Avoiding Utilization Inefficiency in .1Qbv

IEEE 802 Interim Meeting, Norfolk, VA, May/2014
(preliminary version)

Wilfried Steiner, Corporate Scientist
wilfried.steiner@tttech.com

Bandwidth Inefficiency

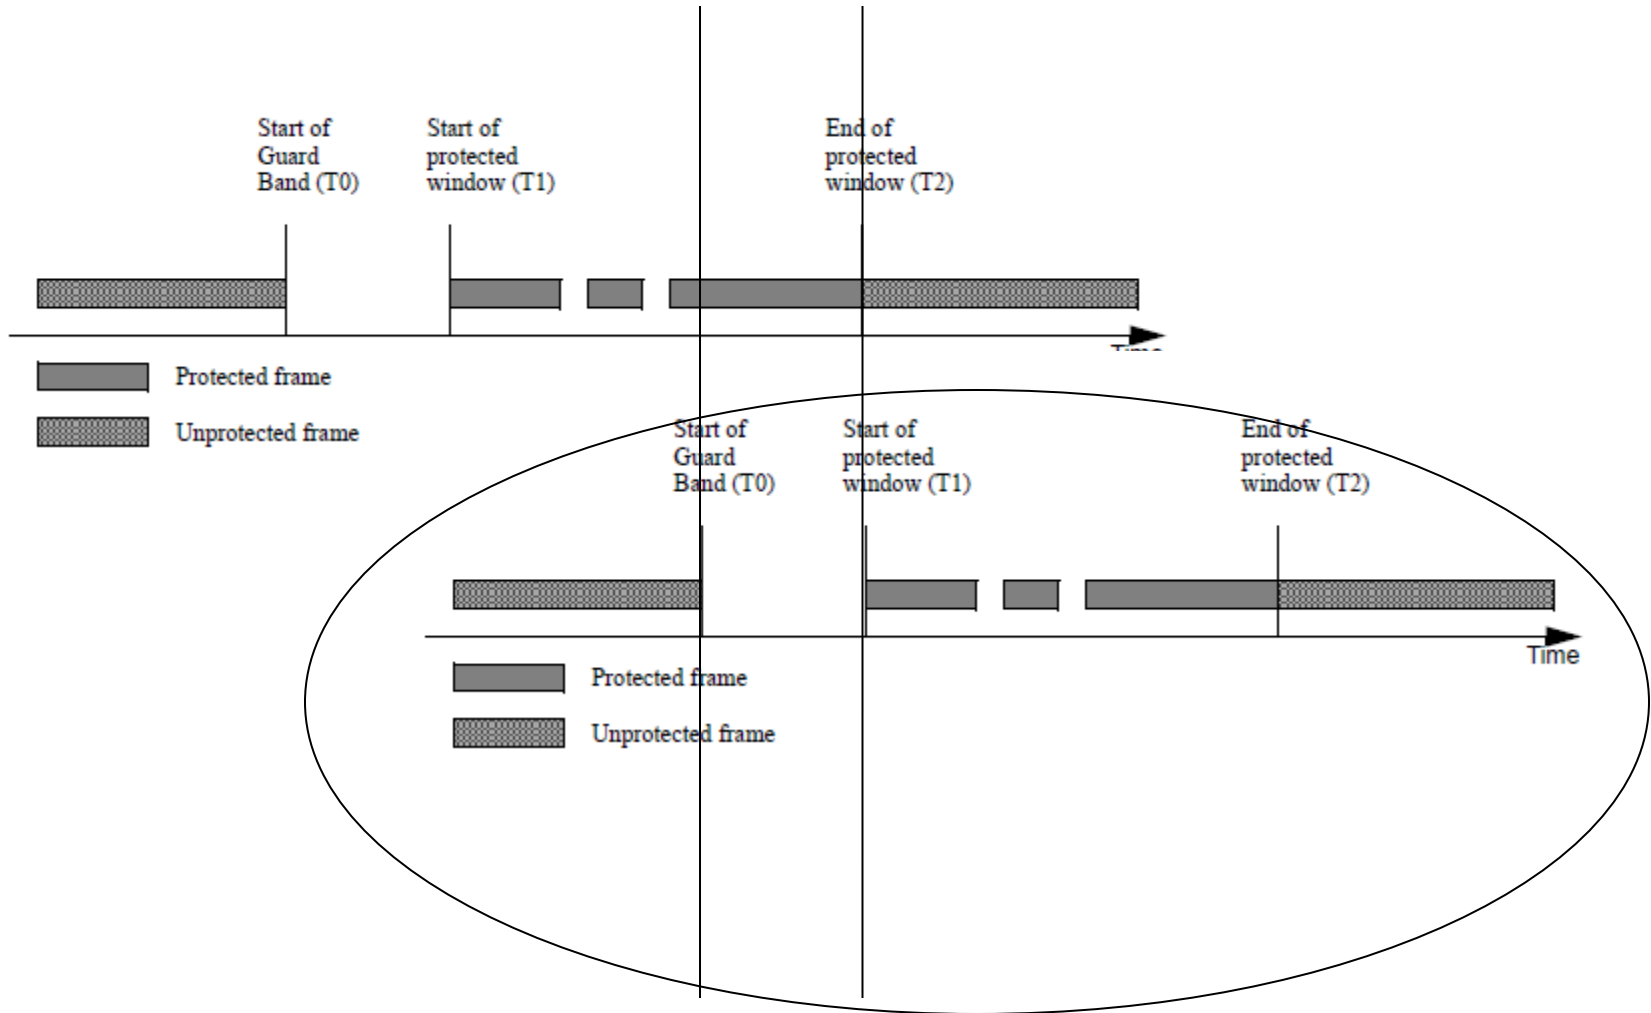
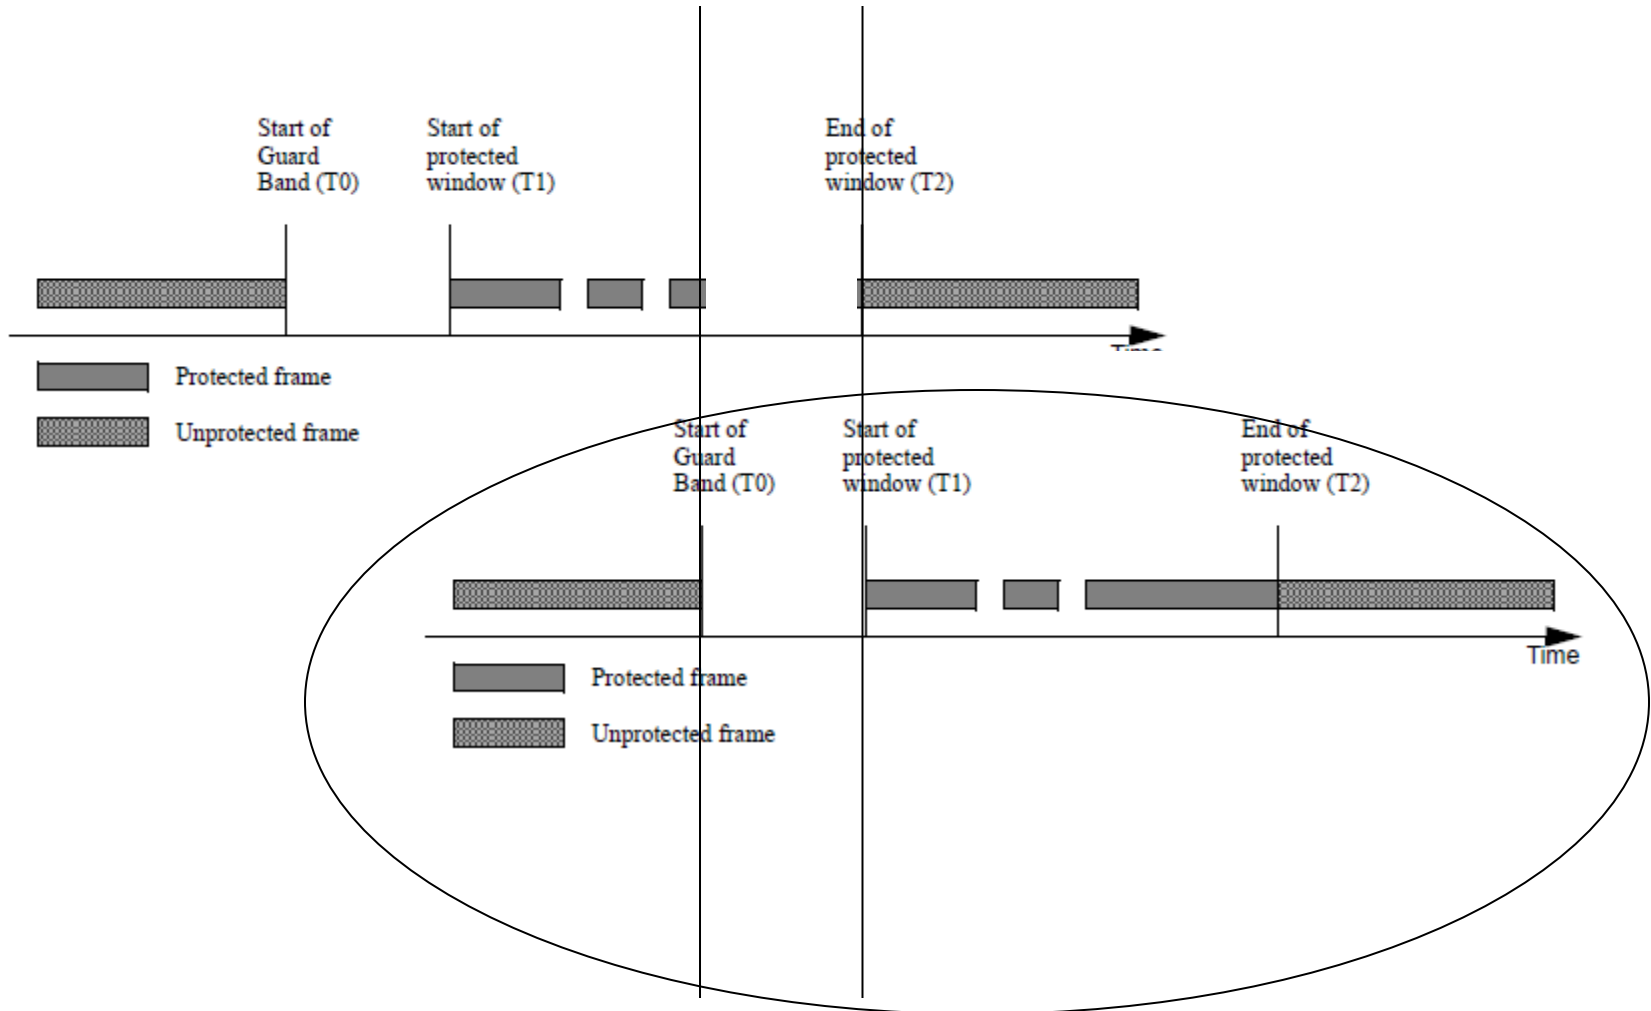
Just duplicating the figure here to show the guard band before the end of T2

Observation 1: the “guard band problem” occurs at every gate-closing event, not only before some “protected window”.

Conclusion 1: simple implementations need to block traffic for about a maximum sized frame before the end of each gate-closing event.

Bandwidth Inefficiency – Intelligent GB Usage

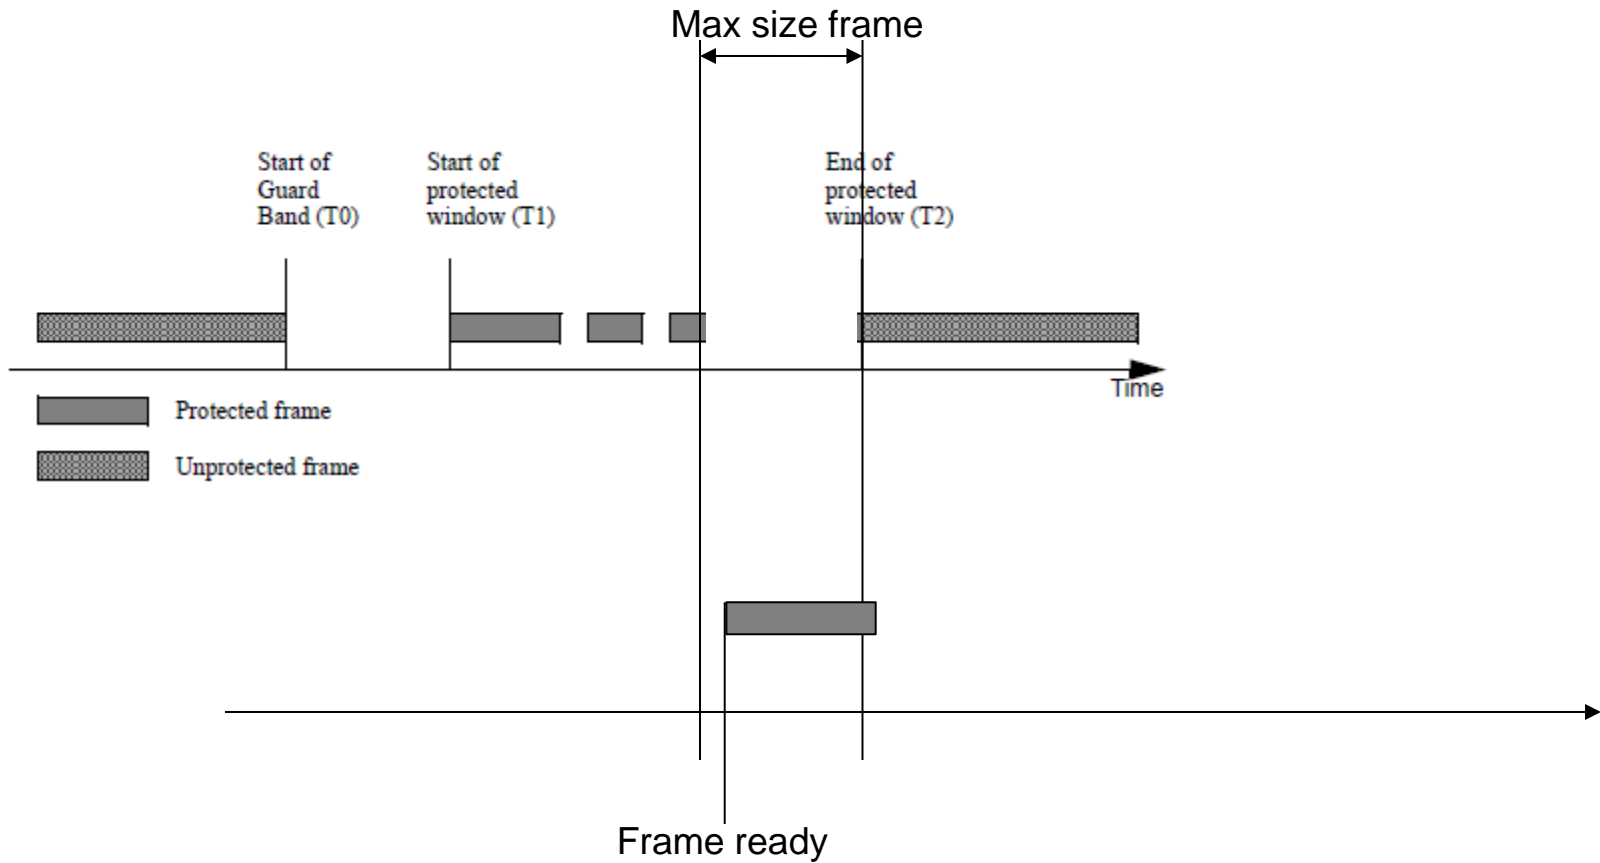
Observation 2: in the worst-case, a slightly smaller frame than the max sized frame becomes ready for relay at a time that is too late for complete transmission.

Conclusion 2: intelligent use of the guard band does not significantly improve the bandwidth utilization in the worst case.

Bandwidth Inefficiency – Intelligent GB Usage

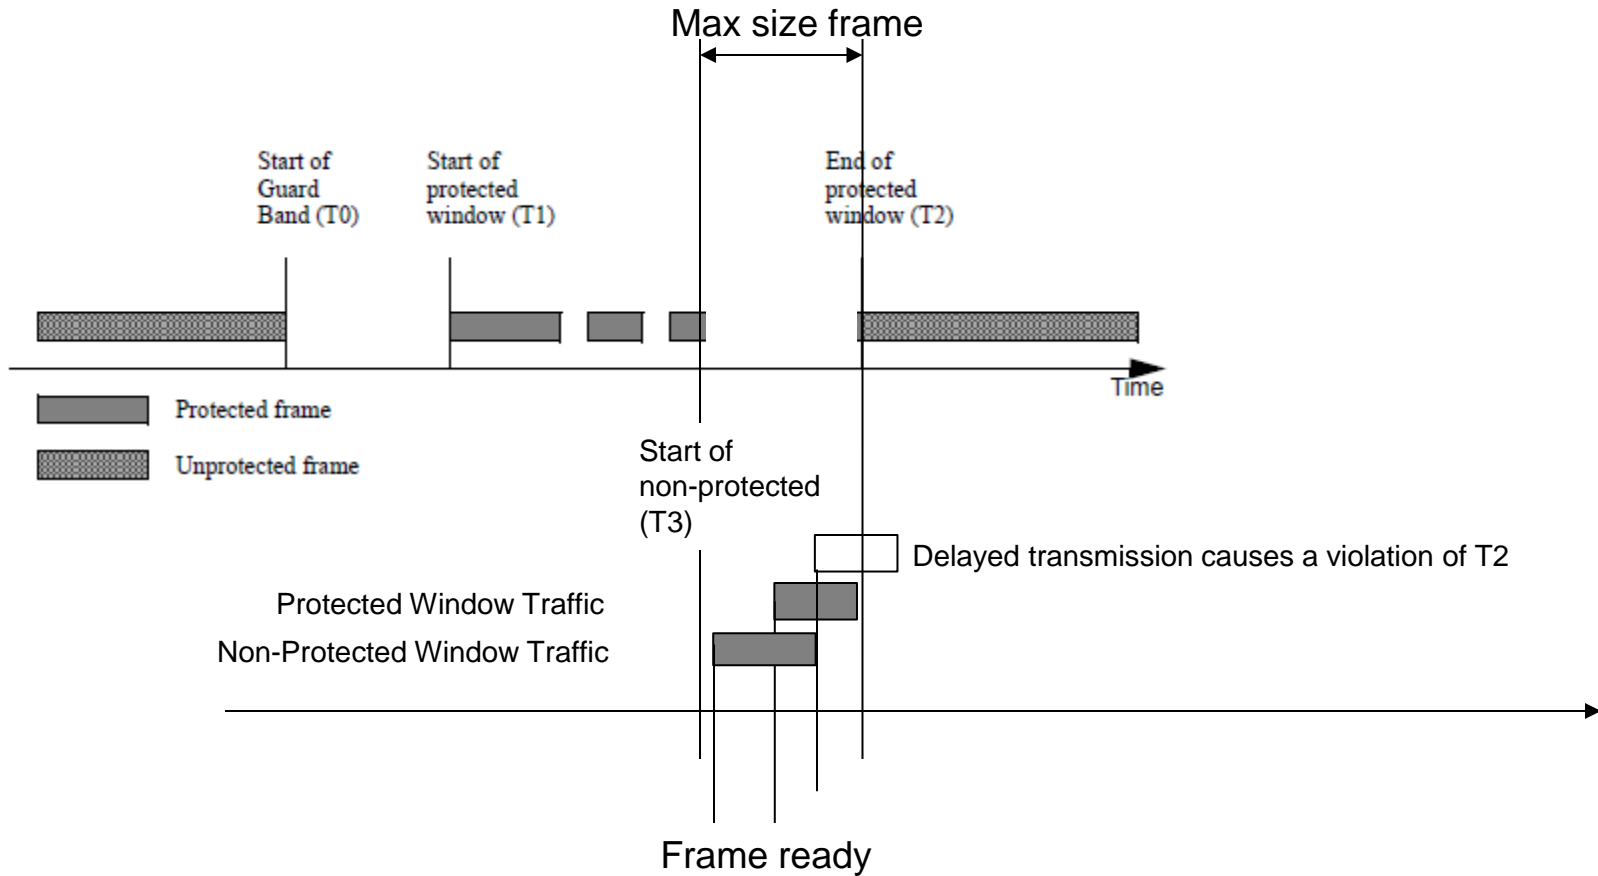
Observation 3: when overlapping windows, there is a threat that lower priority traffic will cause higher priority traffic not to fit into the window.

Conclusion 3: overlapping only at the size of a minimum frame at max.

Proposed Modification

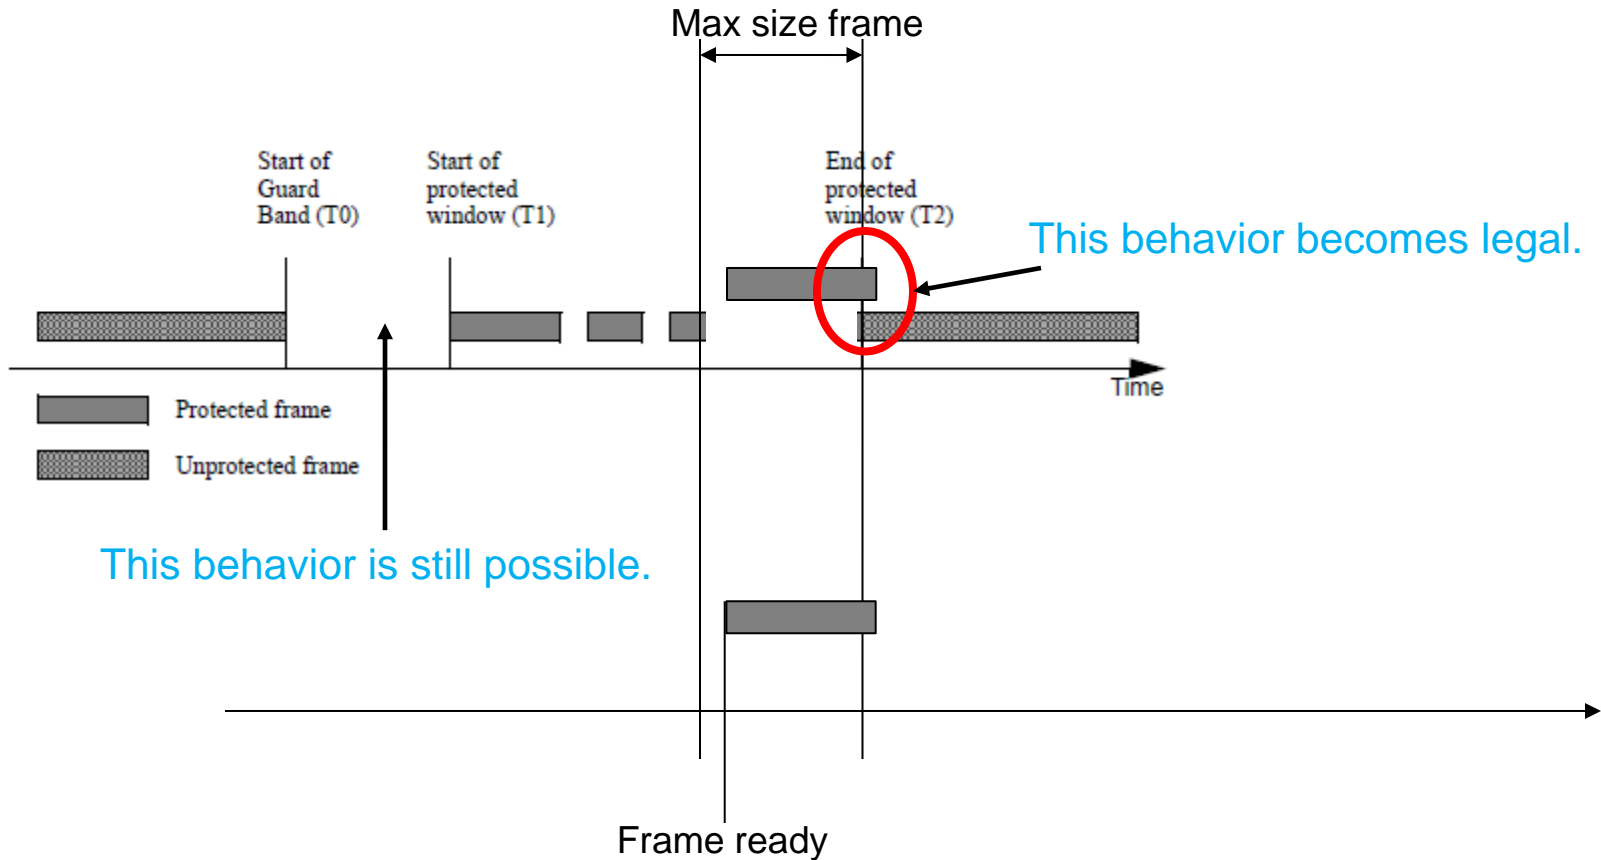
In a Bridge that supports enhancements for scheduled traffic (8.6.8.4), a transmission gate is associated with each traffic class queue. In addition to the other checks carried out by the transmission selection algorithm, a frame on a traffic class queue is not available for transmission (as required for tests (a) and (b) in this clause) if the transmission gate is in the closed state. ~~or there is insufficient time available to transmit the entirety of that frame before the next gate-close event (3.1) associated with that queue.~~

“or there is insufficient time available to transmit the entirety of that frame before the next gate-close event (3.1) associated with that queue.”

... is replaced by additional constraints on the gate event list.
